**DOCUMENT 00 90 00
ADDENDUM**

ADDENDUM NO. [2] Date: October 10, 2019

**RE: LANESBORO PUBLIC SCHOOLS
 ADDITION AND REMODEL REBID
 100 KIRKWOOD ST EAST
 LANESBORO, MN 55949
 HSR 18063**

**FROM: HSR Associates, Inc
 100 Milwaukee Street
 La Crosse, WI 54603
 (608) 784-1830**

E105P

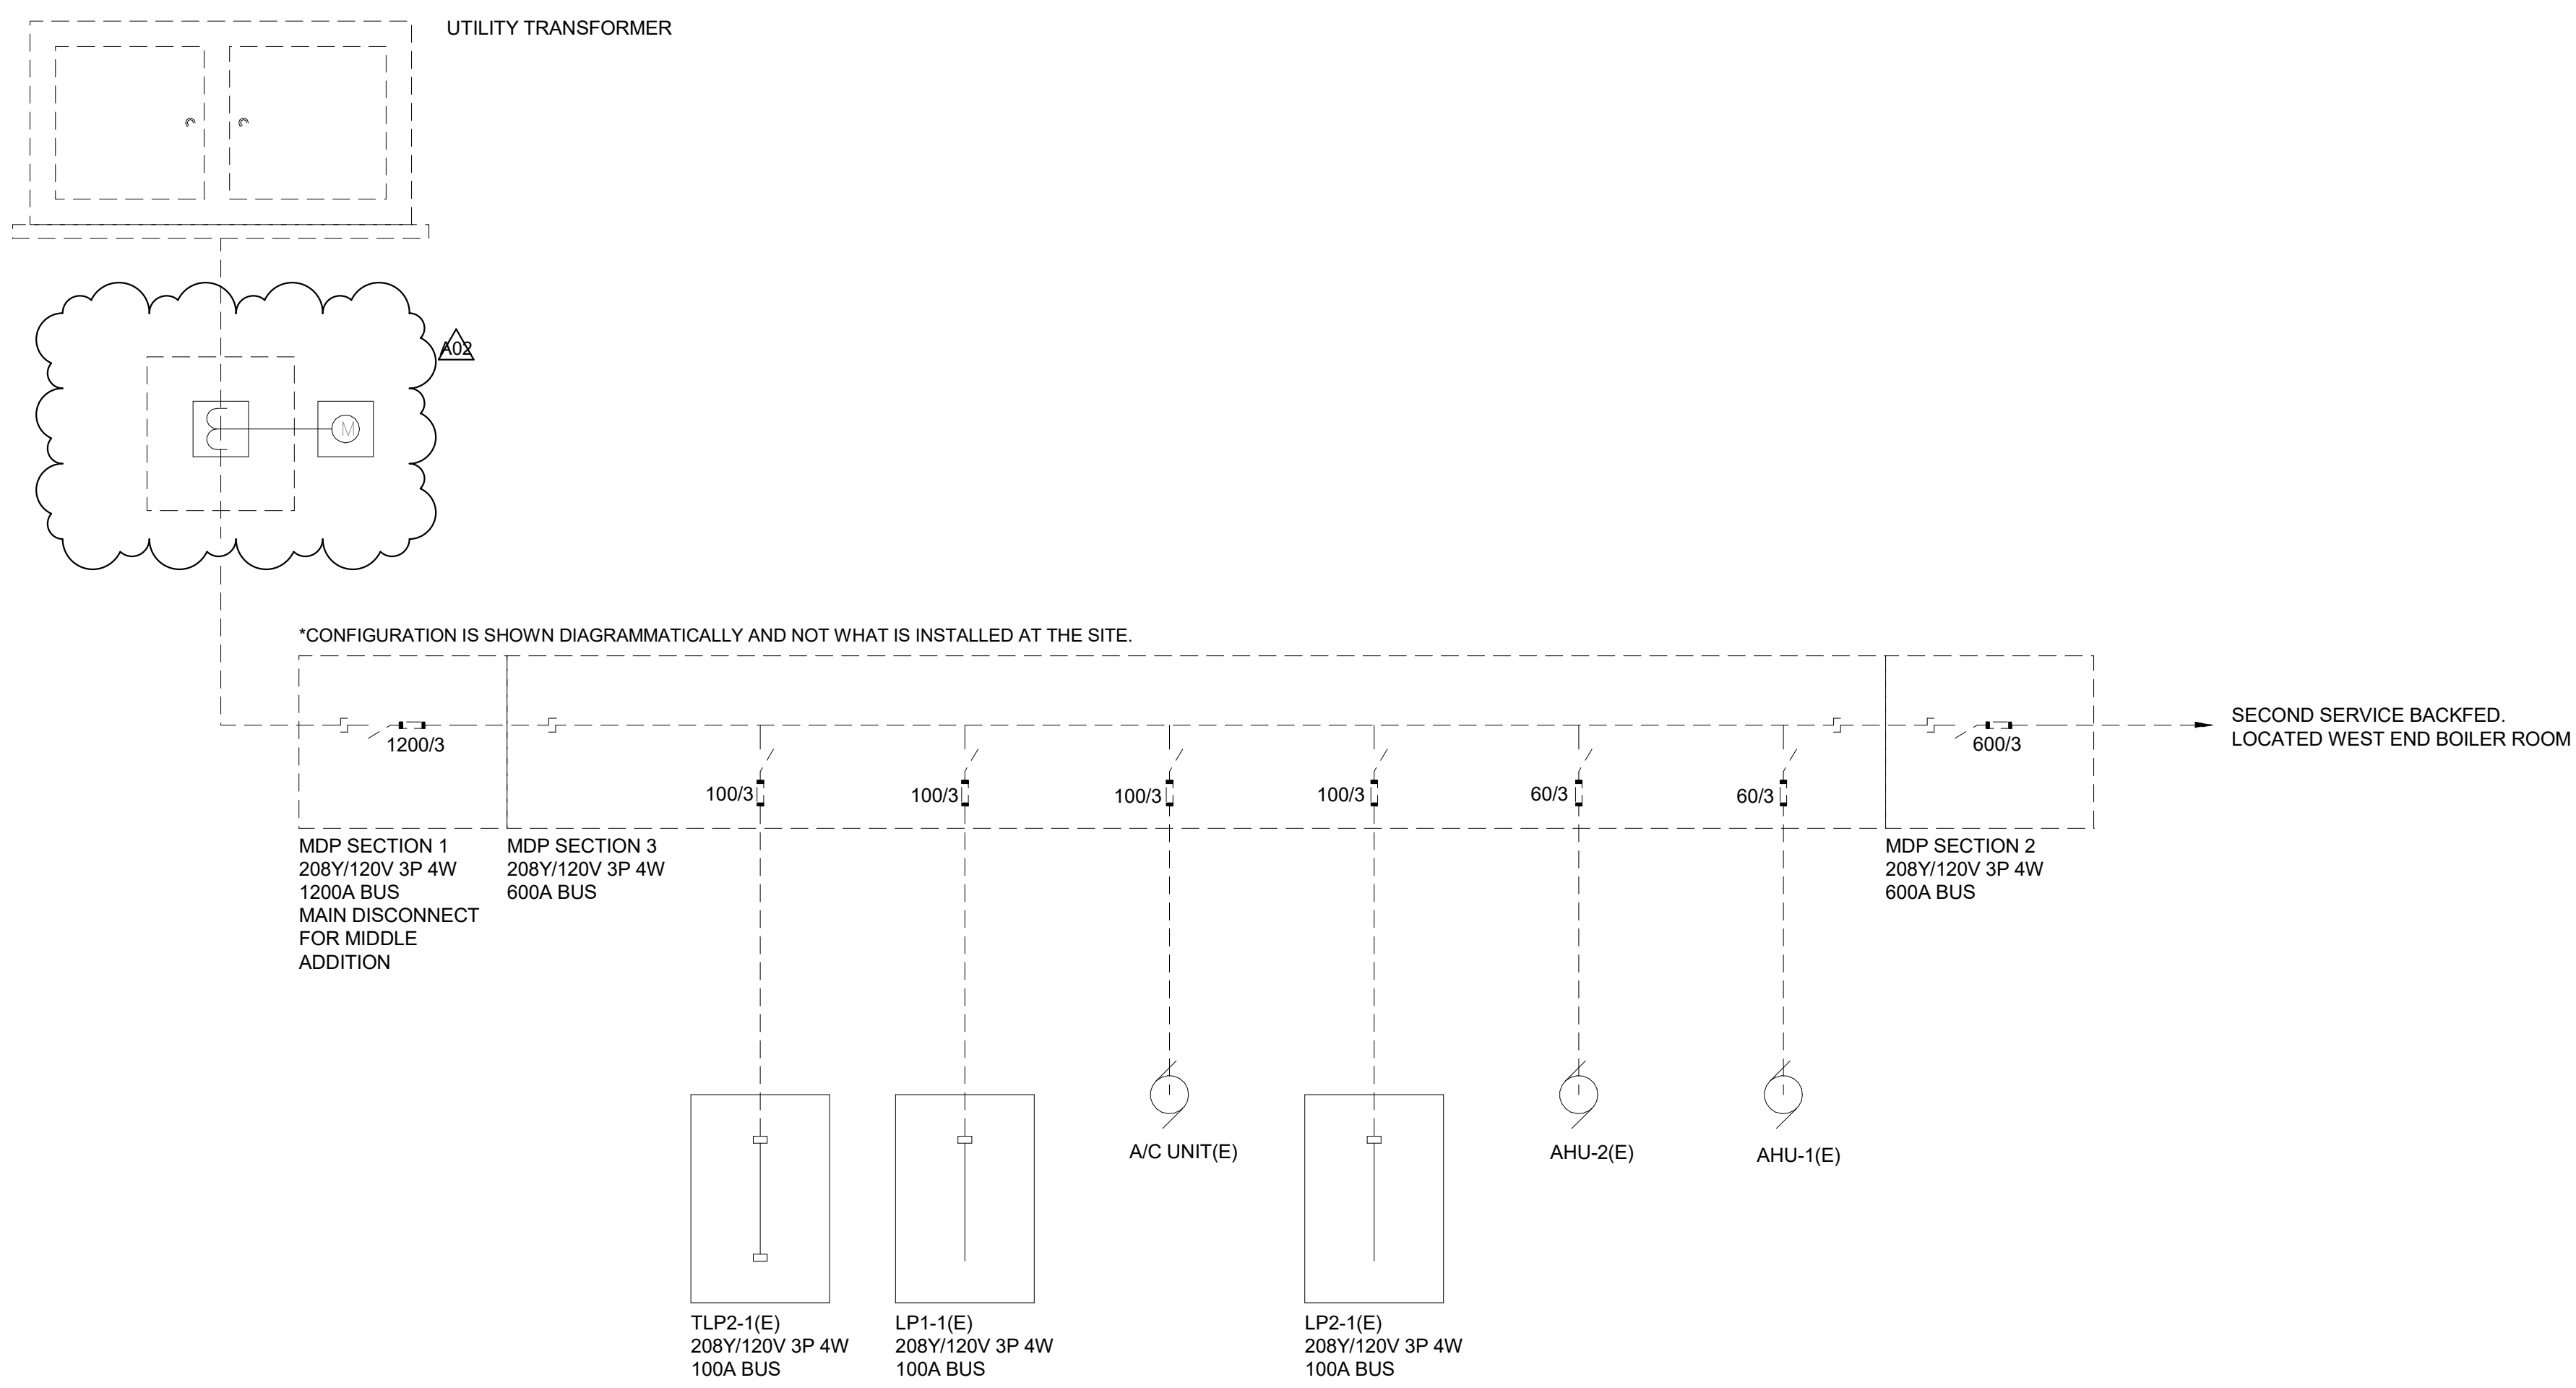
61. Sheet E105P – UPPER LEVEL - SEG C – POWER/SYSTEMS 30 x 42 attached hereto
 - a. Revisions clouded on Drawing
 - b. Add keyed notes 2 and 3 to clarify scope of work for solar/pv conduits and routing, as shown.

2 NEW/EXISTING ONE LINE DIAGRAM - ELECTRICAL
E600 SCALE: NTS

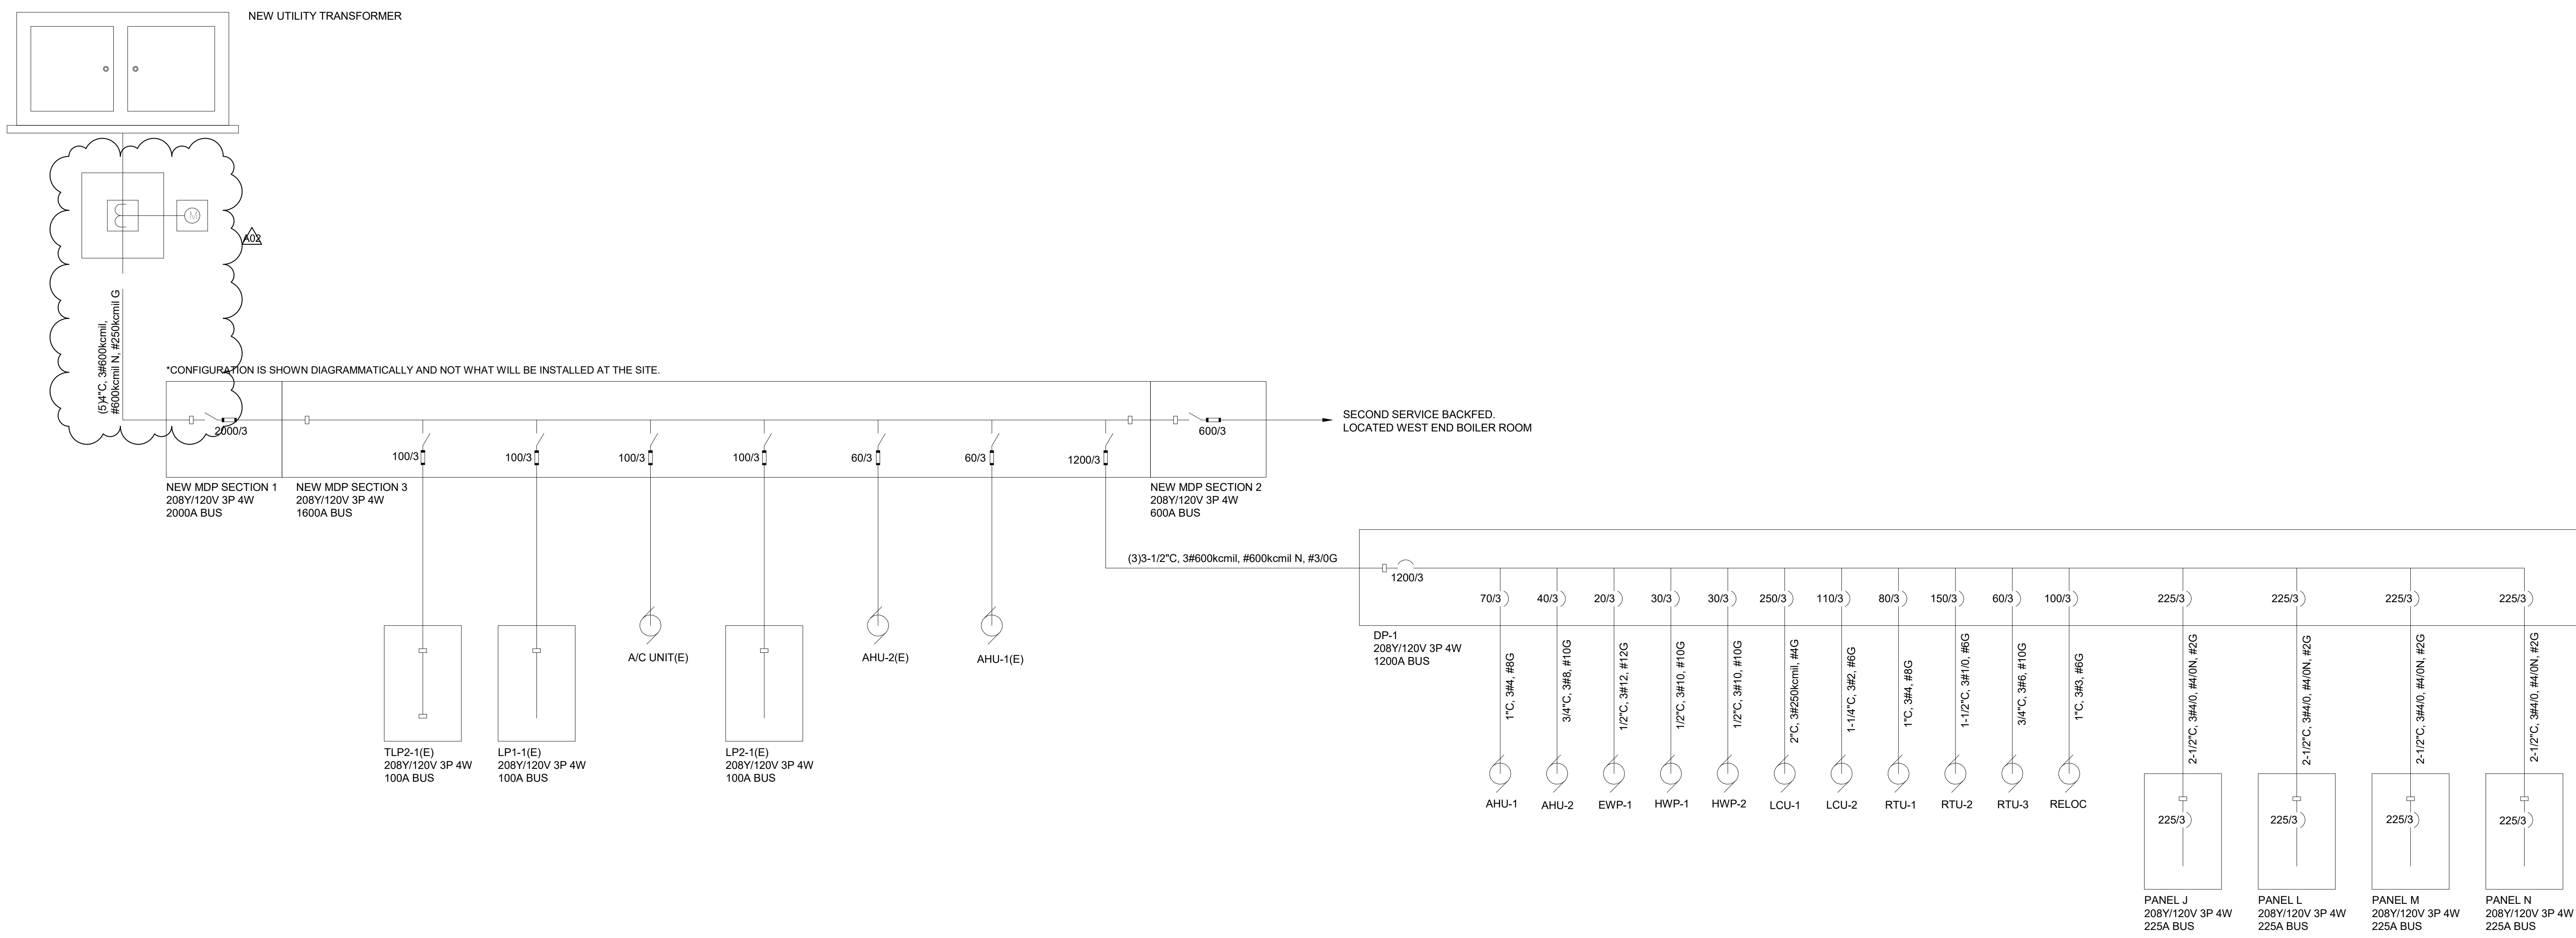
62. Sheet E600 – ONE LINE DIAGRAM – ELECTRICAL 30 x 42 attached hereto
 - a. Revisions clouded on Drawing
 - b. Revise one line diagram to include new ct cabinet and feeder, as shown.
